Subject: Genesis Site Prep Error

An error has been found in the U-Scan Genesis Site Prep manual that may lead installers to improperly install units.

V06_Genesis_SitePrep.pdf

Revision 6, released November 7, 2008

Figure 2.3 Four U-Scan4 Customer Stations with Attendant Station (C)

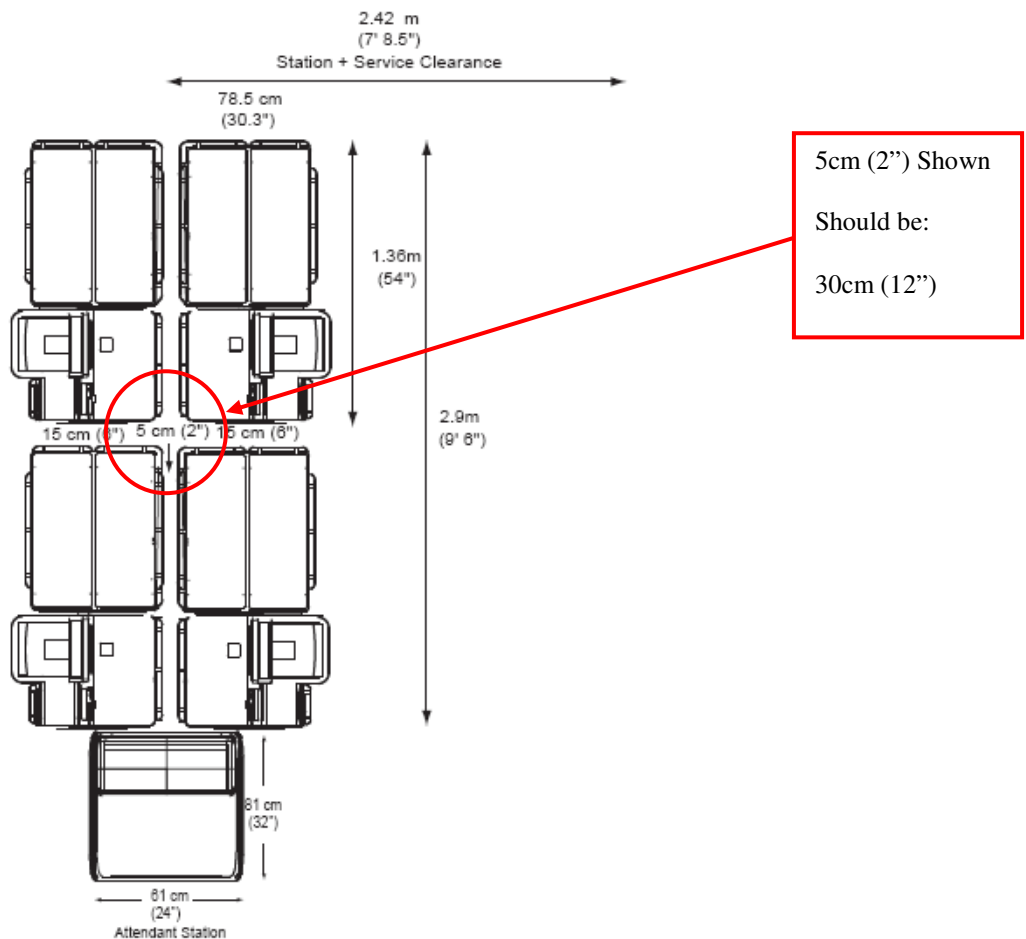
The illustration (see below), indicates that Genesis Robots installed back to back only need 5cm (2 inches) service clearance between rows. This is not correct. The correct dimension is 30cm (12 inches).

This change will be made in a future revision of the document (no anticipated data at this point).
